**AGENDA**  
**Planning & Zoning Commission**  
**Regular Meeting**  
**San Luis Council Chambers**  
**1090 E. Union Street**  
**San Luis, AZ 85349**  
**Tuesday, August 13, 2024**  
**6:00 P.M.**

## PLANNING & ZONING AGENDA ITEM REVIEW FORM

# BIENESTAR ESTATES 12 - PHASE 2 SUBDIVISION

# ORCHIDEA PARK PHASE 1

# BIENESTAR ESTATES 12 - PHASE 2 SUBDIVISION

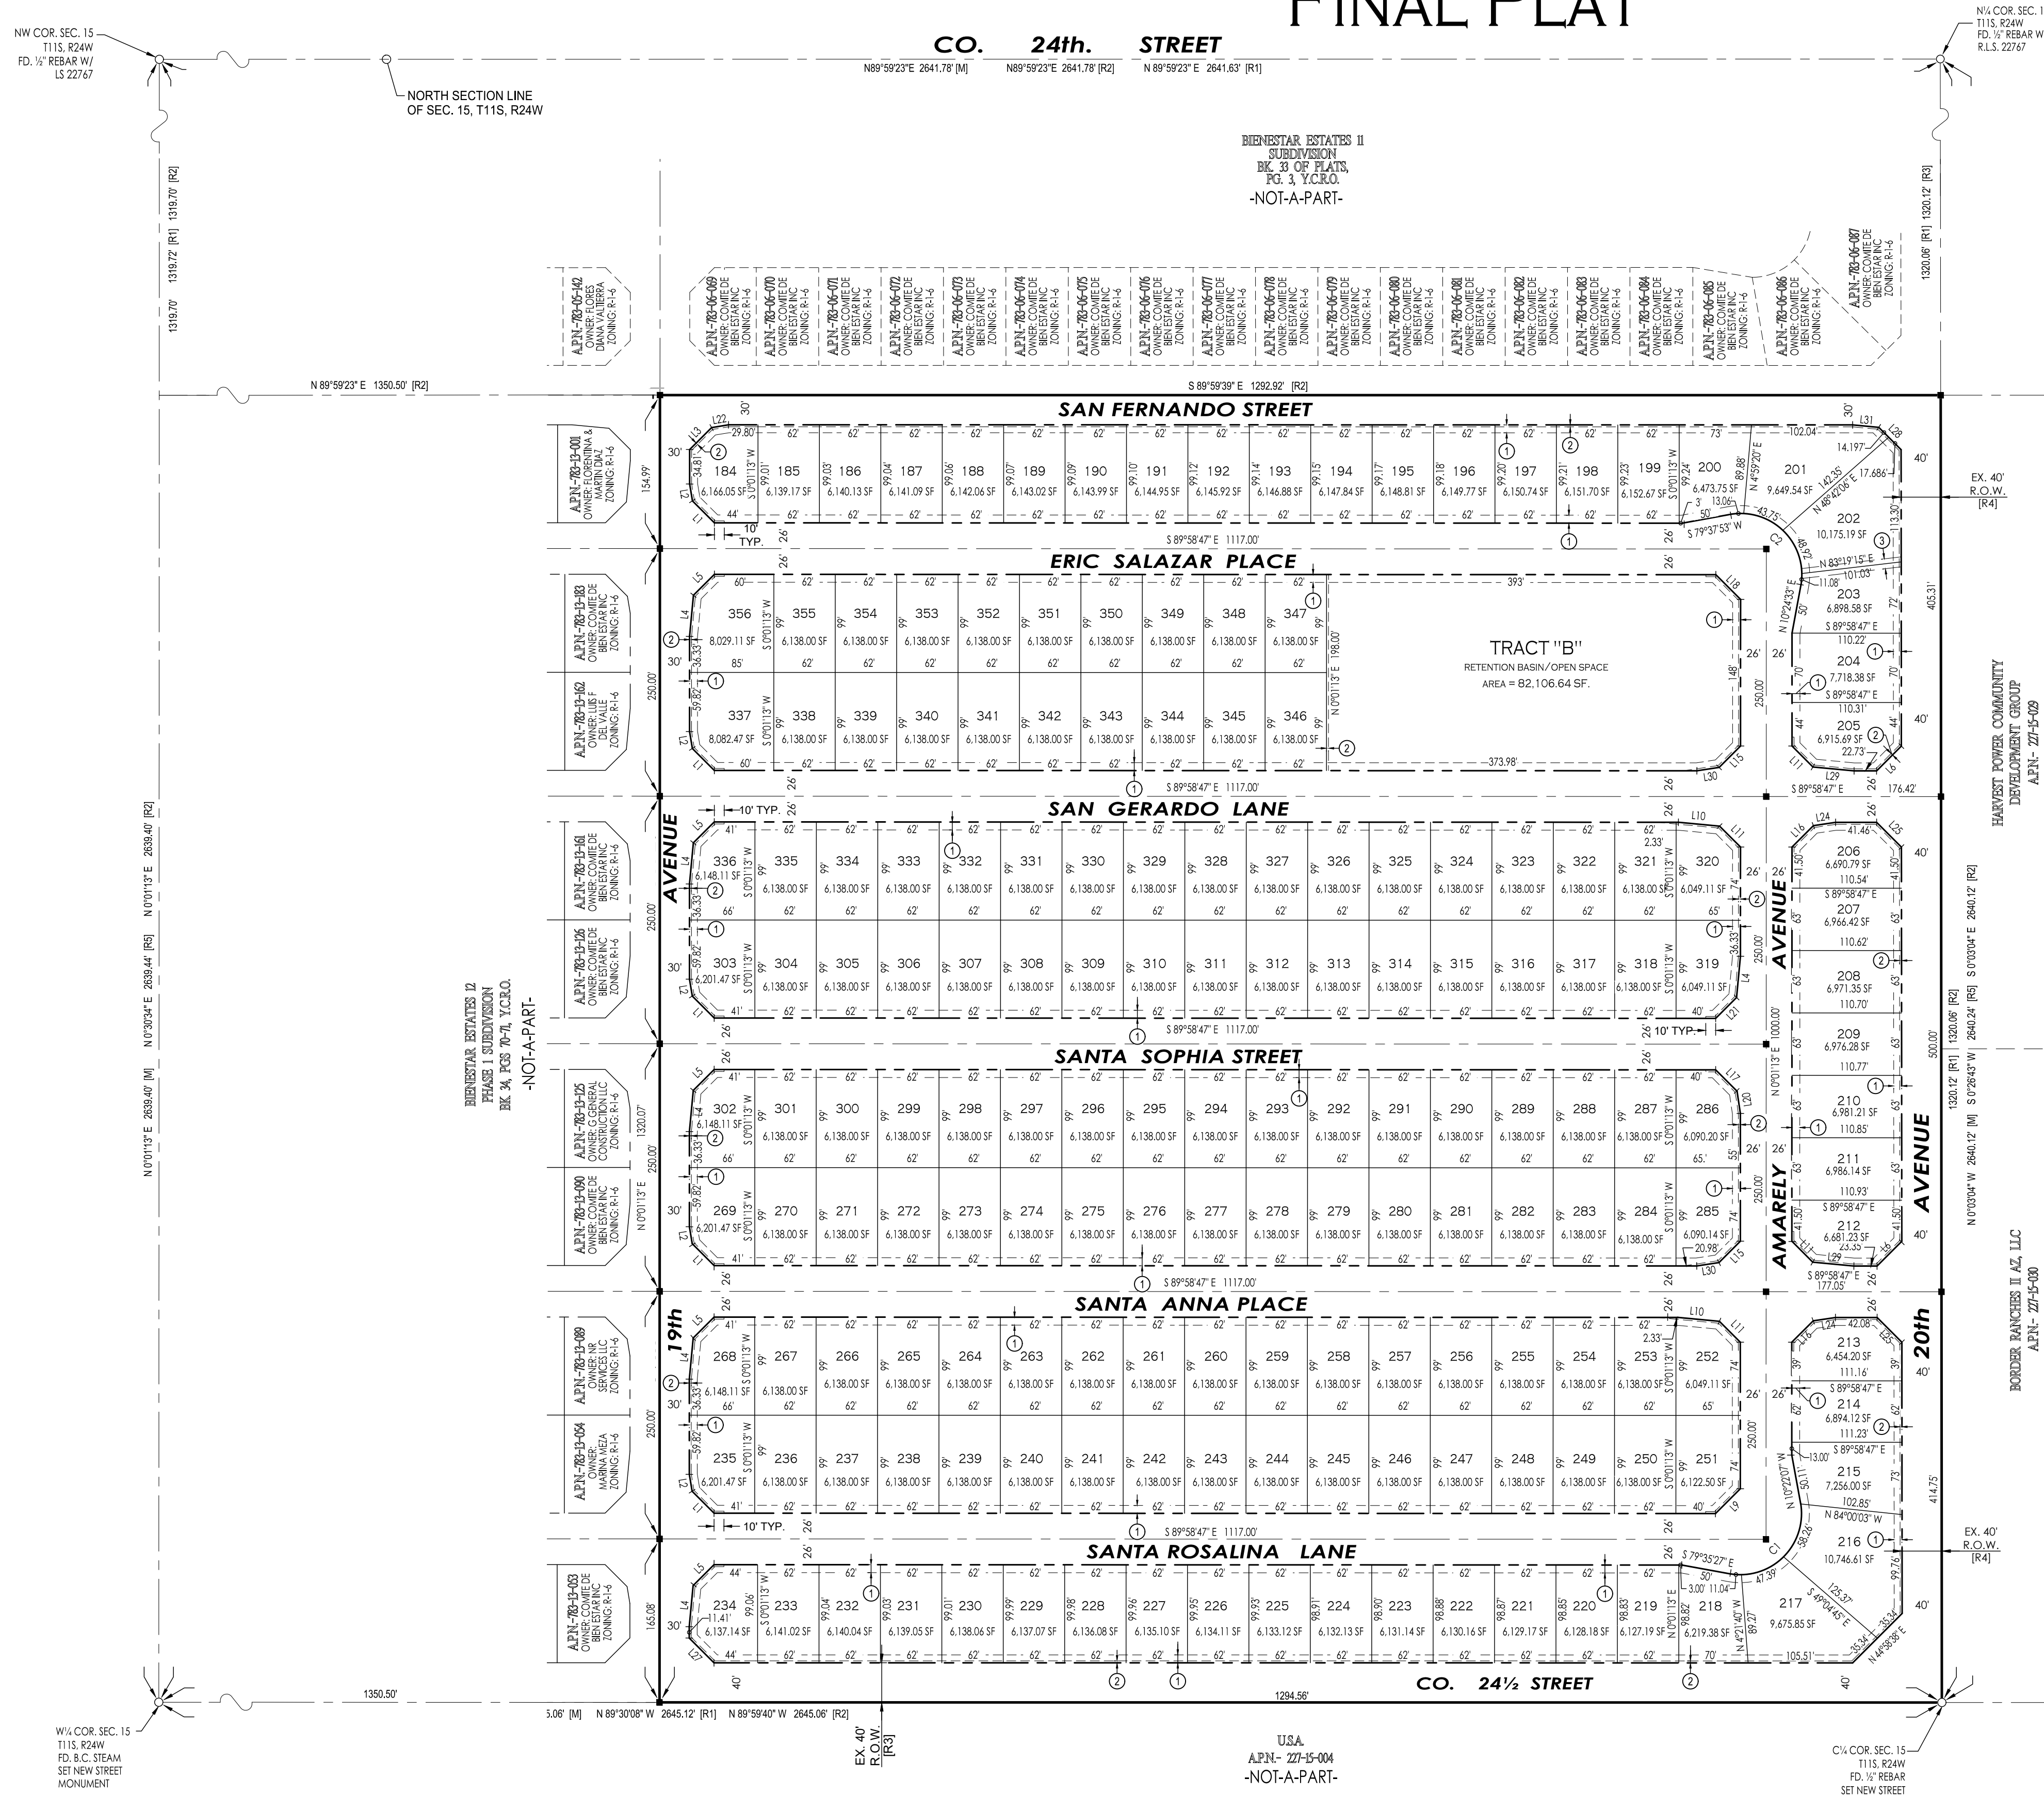
1. Provide CCR's and Title Report.
2. Parcel owner is "Border Ranches AZ LLC", please clarify or revise accordingly.
3. On Approved Section revise "Director of Planning and Zoning" to "Director of Development Services".
4. Dedications section dedicates "Tract A" to City of San Luis while plat only calls out Tract B, revise or clarify accordingly.
5. Provide open space calculation on plat, a 5% open space is required for R1-6 Zoning District.
6. On lots 346 & 346 1' NAE to be on private property side.
7. Tie or show basis of bearing line on plat (Centerline of Avenue F).
8. Reference survey monuments to COY standards.
9. Call out section and mid-section lines as required similar to "North Section Line".
10. As per current Subdivision Regulations subdivider will take such actions as may be necessary to form, establish and include the subdivision in an improvement district.

1. Submit complete drainage report and engineer design report.
2. Show existing elevation contours.
3. Coordinate streetlights to be staggered on 20<sup>th</sup> Avenue with adjacent development.
4. Provide guard post location and spacing on 13' spillways.
5. Provide distance from centerline for stormdrain pipes.
6. Keynote No. 13 - please reference detail accordingly.
7. Northwest corner of 19<sup>th</sup> Avenue and Eric Salazar Place identify correct Curb/gutter elevation.
8. Coordinate 20<sup>th</sup> Avenue grading with Belleza del Desierto Unit 3 from Core Engineering.
9. Curb return radius for ramp on 20<sup>th</sup> Avenue and County 24 1/2 intersection to be 40'.
10. County 24 ½ Street and 20<sup>th</sup> Avenue section's to have a 6' wide sidewalk.
11. General Notes: Update notes to reference City of San Luis.

12. Provide walking pathway on retention basing along lots 346 and 347 to connect San Gerardo Lane and Eric Salazar Pl.
13. Provide additional lighting on retention basin for common area recreational amenities.
14. The City is looking into requiring amenities on retention basin areas for the benefit of the residents on all residential subdivision projects. Staff is finalizing the requirement through the City of San Luis Subdivision Regulations update. This requirement will be recommended to City Council prior to the adoption of the updated City of San Luis Subdivision Regulations. Sush amenities should include but are not limited to playgrounds, ramada with picnic tables and barbeque grill, etc.

1. Provide ADEQ permits.
2. Coordinate water and sewer with adjacent development to the east, Belleza del Desierto Unit 3 from Core Engineering.
3. Add dimension from centerline to water and sewer mains.
4. Add thrust block on 90 degree ell on Eric Salazar Place and Amarely Avenue.
5. Sanitary sewer manholes need to be polymer manholes as per City of San Luis Supplement to the MAG Uniform Standard Specifications.
6. Provide fire hydrant street markers as per COY Std. No. 5-160.
7. Sheet 10. Reference General Note to City of San Luis as necessary.

1. Assure design meets City of San Luis Standards. Any deviations from City Standards need City of San Luis approval prior to incorporating into the design. Update General Notes to reflect this.
2. Provide traffic study for this development.

1. Run storm drain pipe along 20th Avenue and San Gerardo Lane into the retention basin.
2. Include invert elevation at storm drain entrance.
3. Are all cross gutters needed on San Gerardo and Amarely?
4. Suggest that CMU wall callout be modified so that the 6 foot height requirement is on the side of highest elevation.
5. As a recommendation – Provide a pedestrian pathway connecting San Gerardo and Eric Salazar.
6. Include barricade at San Fernando and 20th Avenue and 19th Avenue and Co. 24 ½ St.
7. The City uses dual mast arm street lights next to retention basins. Final street light design will be coordinated with APS.

After review, it appears that the proposed subject action will occur adjacent to Bureau of Reclamation property. Our agency will require to review any design plans for the subject project to ensure the project will not encroach within the Federal lands. Should the project encroach, Reclamation will require a right-of-use authorization is in place before any project activities occur within the Federal lands.
